DRAFT ENGINEERING ADDENDUM

US 17 (SR 5/Main Street)

**From New Berlin Road to Max Leggett Parkway
FM # 209411-3, 209411-8, 209411-9**

The purpose of this Engineering Addendum is to document changes between the PD&E and Design Concepts, and record their impact to the social, cultural, natural, and physical environment.

Figure 3-1: Typical Section for Design Concept

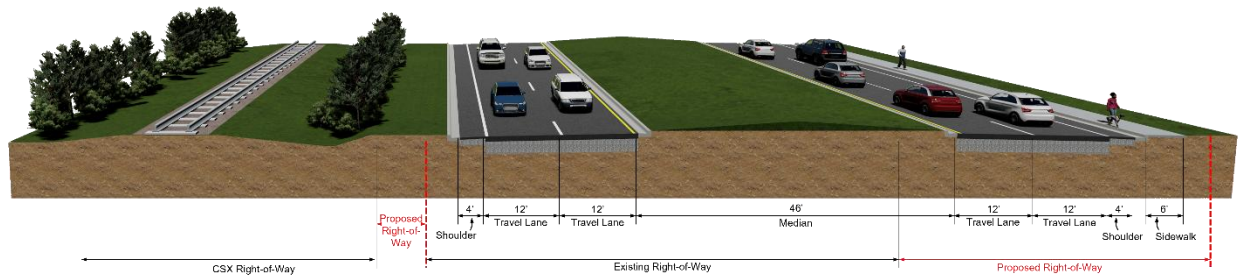
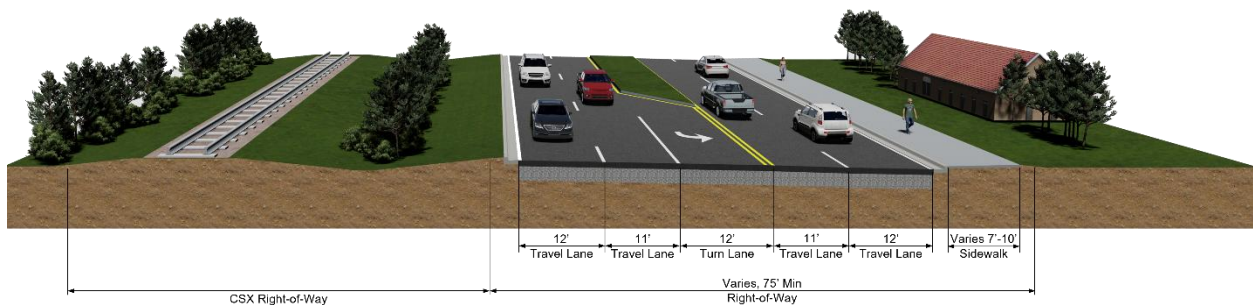
Therefore, the typical section for the proposed widening was changed during the Design phase. The Design Concept replaced the 46-foot median with a single 10 to 12-foot turn lane.

The PD&E Concept typical section consisted of four 12-foot travel lanes, 46-foot median, and four-foot bike lanes as well as a six-foot sidewalk in the northbound direction. No sidewalk was proposed on the west side due to proximity to the CSX railroad, see **Figure 2-1**.

The Design Concept's new typical section introduces multiple key adjustments and provides four lanes including two 12-foot outer lanes and two 11-foot inner lanes, a 12-foot median (accommodating intermittent left turn lanes) and a sidewalk ranging from 7 to 10 feet in width. This new alternative is designed to accommodate both pedestrians and cyclists on the east side of the road. The wider sidewalk will connect US 17 to Woodland Drive, along Cole Road, and funding is structured such that this connection may be constructed separately from the US 17 improvements. The Design Concept Typical Section is shown in **Figure 3-1**.

Figure 2-2: PD&E Concept at US 17/New Berlin Road/Cole Road

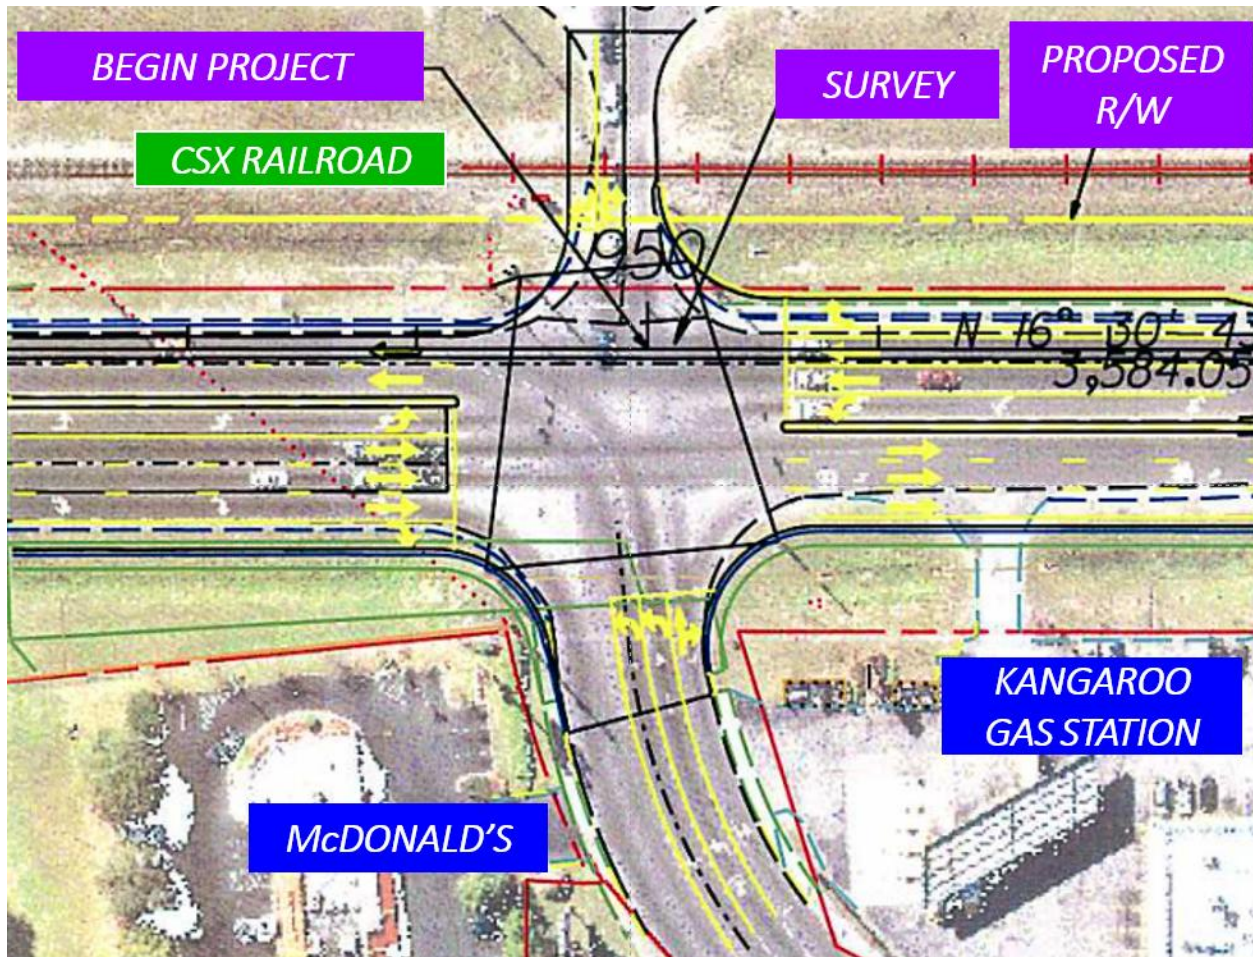
- Addition of a through lane and conversion of the shared right-turn lane to an exclusive right-turn lane at the south leg
- Addition of a through lane at the north leg

The Design Concept consists of two new signalized intersections approximately 500 feet downstream in either direction, which will be used for U-turn movements to replace the direct left-turns. These new intersections will also be used to process through traffic on New Berlin Road/Cole Road. **Figure 3-2** illustrates the concept presented at the Public Hearing. However, based on public feedback, the design was changed to allow northbound left turn movements at the intersection. The updated concept is shown in **Figure 3-3**.

Figure 3-4: Design Concept at US 17/Oceanway Avenue

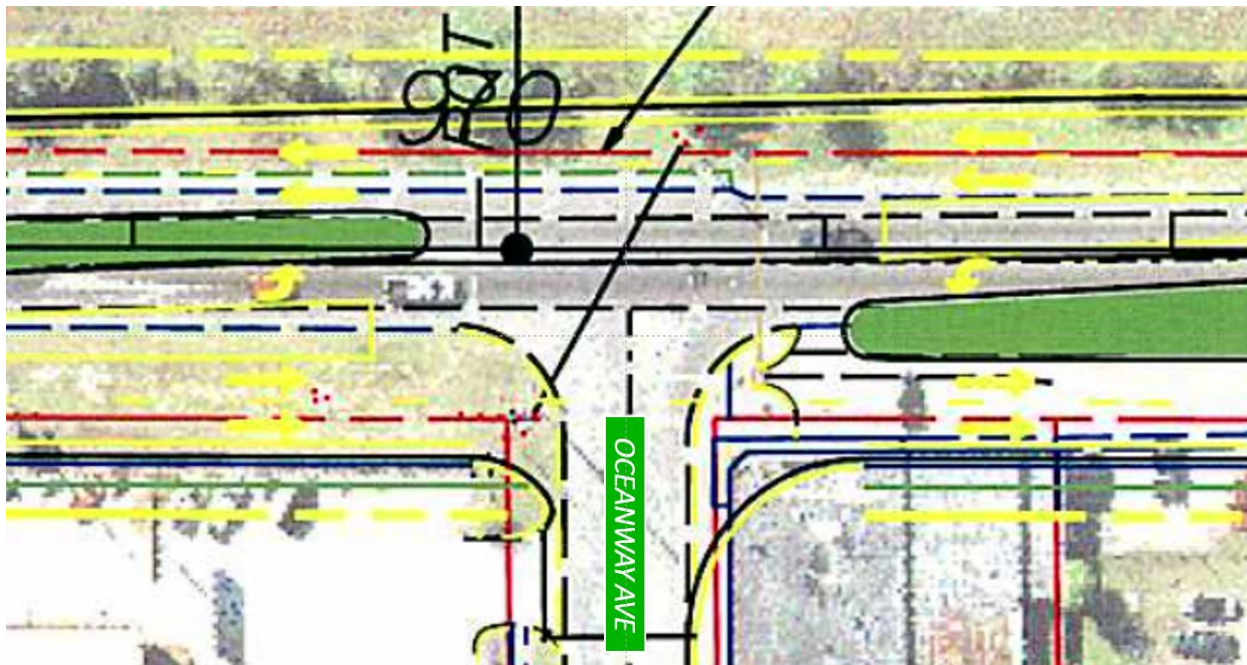
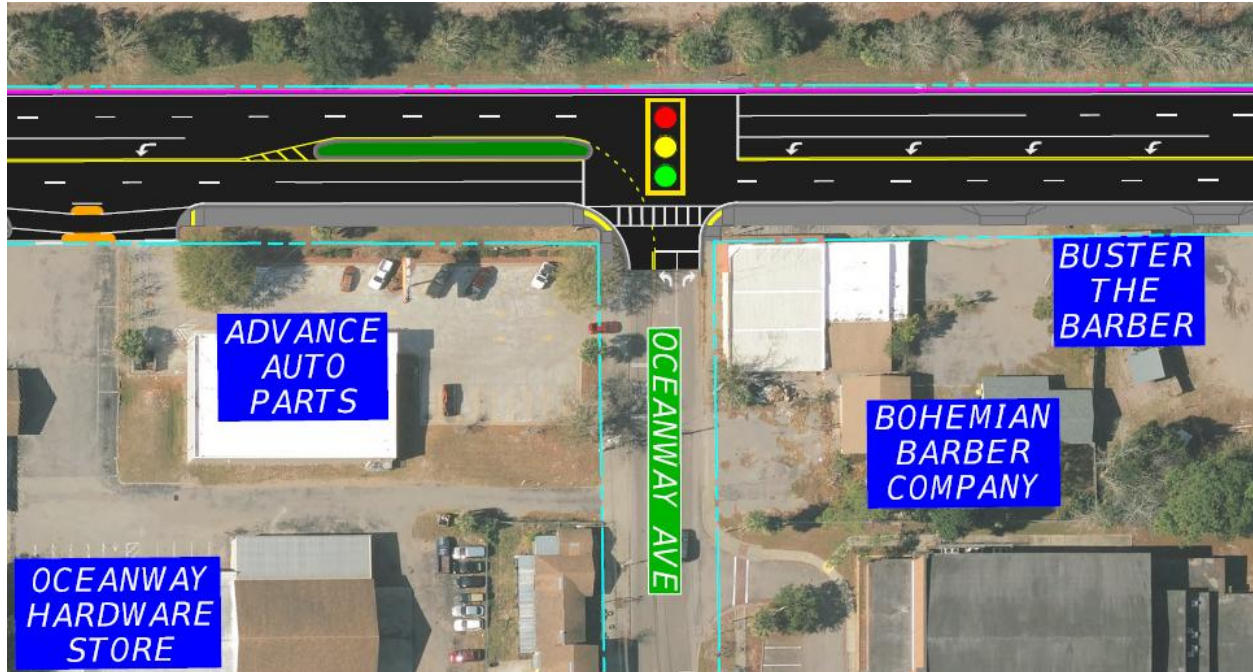
- Addition of a through lane and a left-turn lane (for U-turn movement to proceed southbound) at the south leg
- Addition of a through lane at the north leg

The Design concept provides two through lanes for the northbound traffic and no left-turn lanes, as well as two through lanes and one left-turn lane for the southbound traffic. **Figure 3-4** shows the configuration at the US 17/Oceanway Avenue intersection.

Figure 2-4: PD&E Concept at US 17/Airport Center Drive

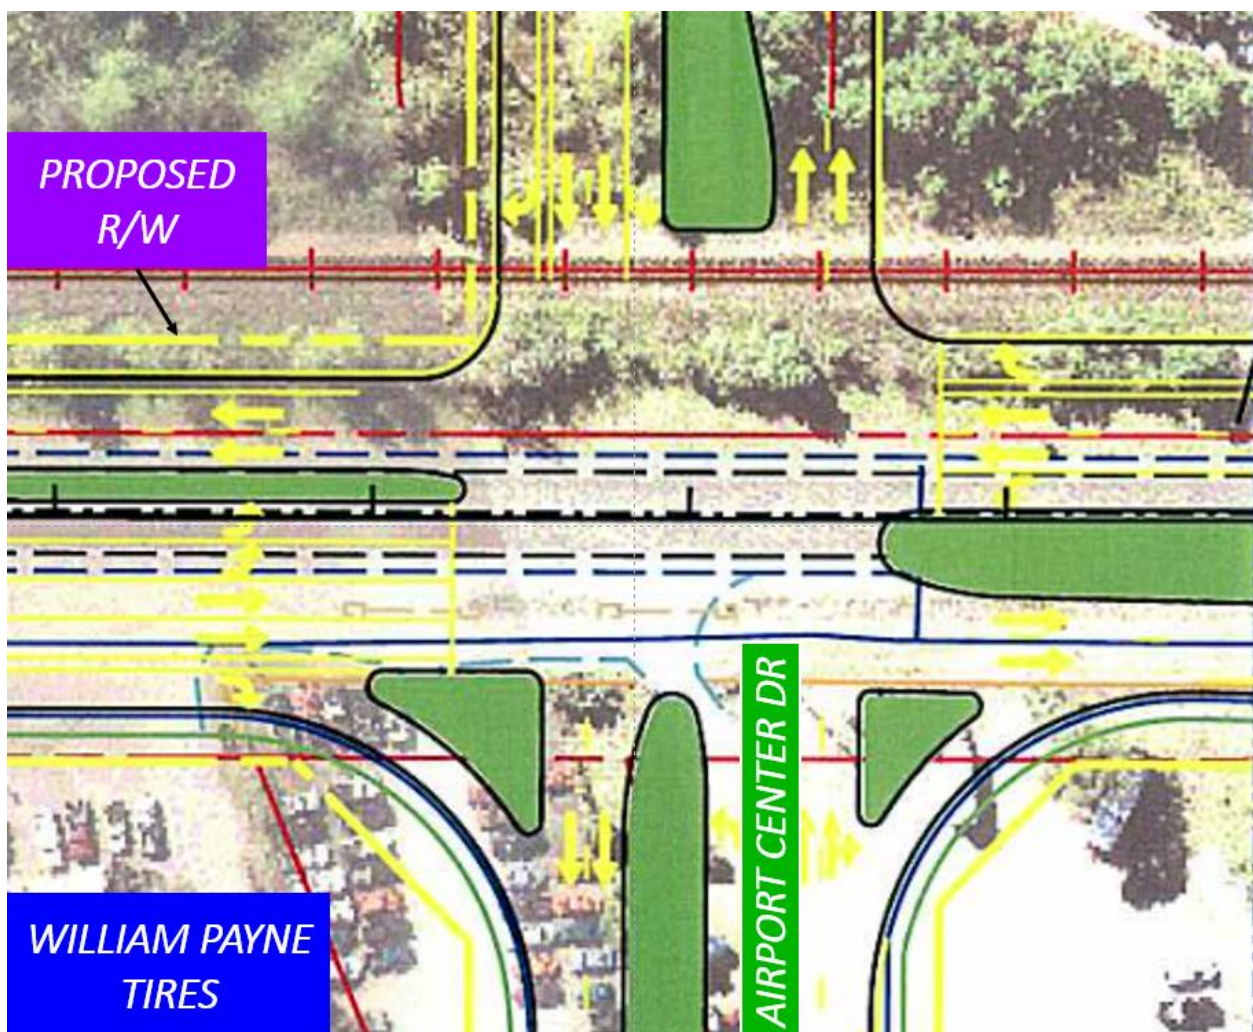
- Addition of a through lane in the south leg
- Addition of a through lane in the north leg
- Addition of a left-turn lane in the east leg

Two left-turn lanes along with two through lanes and an exclusive right-turn lane were proposed for the northbound US 17 traffic. One left-turn lane along with two through lanes and an exclusive right-turn lane were proposed for the southbound US 17 traffic. **Figure 3-5** shows the configuration at the US 17/Airport Center Drive intersection.

Figure 2-5: PD&E Concept at US 17/Max Leggett Parkway/Duval Station Road

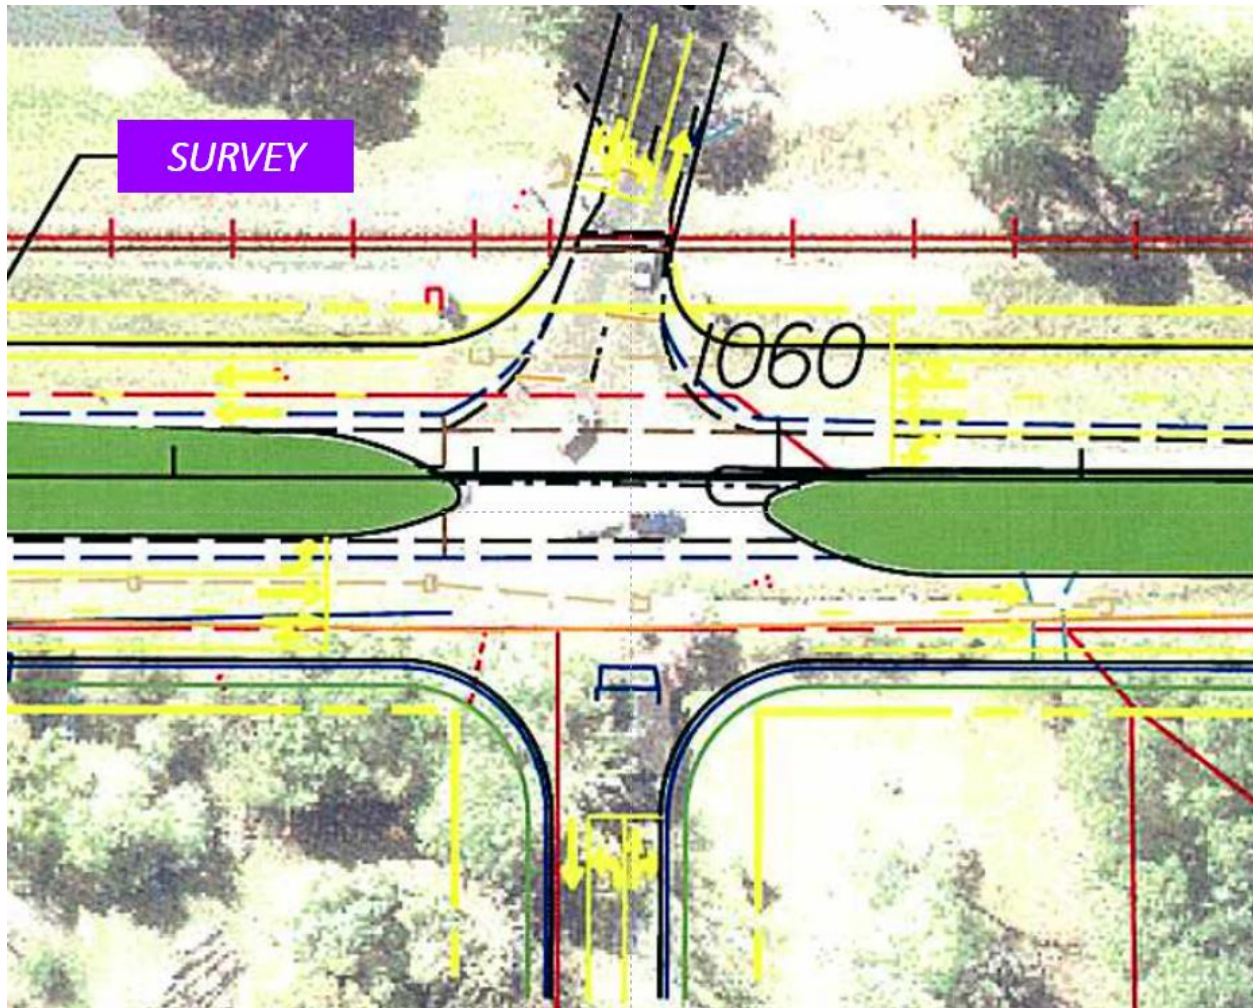
- Conversion of the exclusive right-turn lane to a shared right-turn lane at the south leg
- Conversion of the exclusive right-turn lane to a shared right-turn lane at the north leg
- Addition of a shared right-turn lane on the west leg

Due to the change in project limit, the 4-lane widening ends at this intersection for the Design Concept. The outside northbound through lane will be dropped as a right-turn lane past this intersection. The southbound through lane will be added south of this intersection. One left-turn lane, one through lane, and one shared through/right-turn lane will be proposed for the northbound direction. One left-turn lane, one through lane, and one right-turn lane will be proposed for the southbound direction. **Figure 3-6** shows the configuration at the US 17/Max Leggett Parkway/Duval Station Road intersection.
